Access Compliance Report

Public Rights-of-Way

Intersection ID: 21073	Main Street: COLONY_RD	Cross Street: SHARON_VIEW_RD	Location: NE
ADA ID: 1A7EB9831601	Ramp Type: PerpDiag	Initial Pass/Fail: Fail	Overall Compliance: No
		Severity Score: 22.5

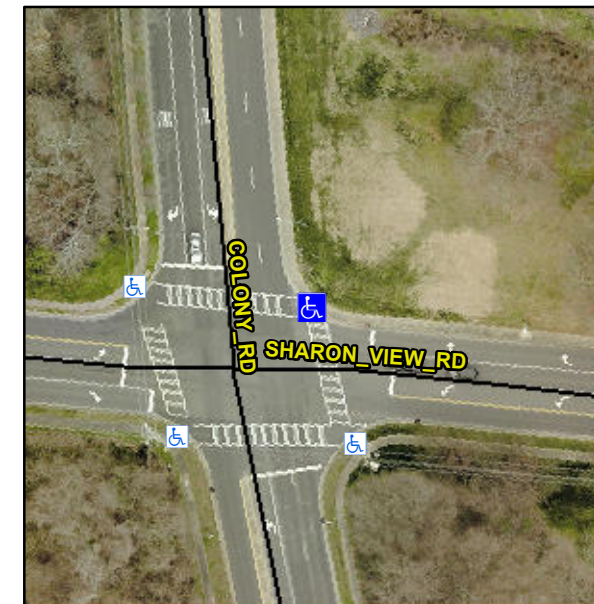
R304.5.1, R304.2.2, R304.5.3

Compliance	Description	Data	Compliance	Description	Data
N/A	Ramp Length (in)	57.0	No	Ramp Slope (%)	10.5
No	Ramp Width (in)	44.0	No	Ramp XSlope (%)	2.7
N/A	Flare Type LT	N/A	N/A	Flare Type RT	N/A
N/A	Flare Slope LT (%)	N/A	N/A	Flare Slope RT (%)	N/A
N/A	Flare Traversable LT?	N/A	N/A	Flare Traversable RT?	N/A
N/A	Landing Length (in)	N/A	N/A	DWS Provided?	N/A
N/A	Landing Width (in)	N/A	N/A	DWS Contrast?	N/A
N/A	Landing Slope (%)	N/A	N/A	DWS Length (in)	N/A
N/A	Landing X Slope (%)	N/A	N/A	DWS Full Width?	N/A
N/A	Landing Curb? (Y/N)	N/A	N/A	DWS Offset (in)	N/A
N/A	Shared Landing?	N/A			
N/A	Gutter Ponding?	N/A	N/A	Gutter Slope (%)	N/A
N/A	Gutter Lip Ht (in)	N/A	N/A	Gutter X Slope (%)	N/A
N/A	Painted X Walk1?	Yes	N/A	Painted X Walk2?	Yes
	X Walk 1 Direction	To NW		X Walk 2 Direction	To S
N/A	X Walk 1 Width (in)	112.0	N/A	X Walk 2 Width (in)	104.0
	X Walk 1 Slope (%)	3.8		X Walk 2 Slope (%)	1.8
	X Walk 1 X Slope (%)	1.4		X Walk 2 X Slope (%)	1.5

Remove & Replace Curb Ramp With Two New Directional Ramps or Equivalent.
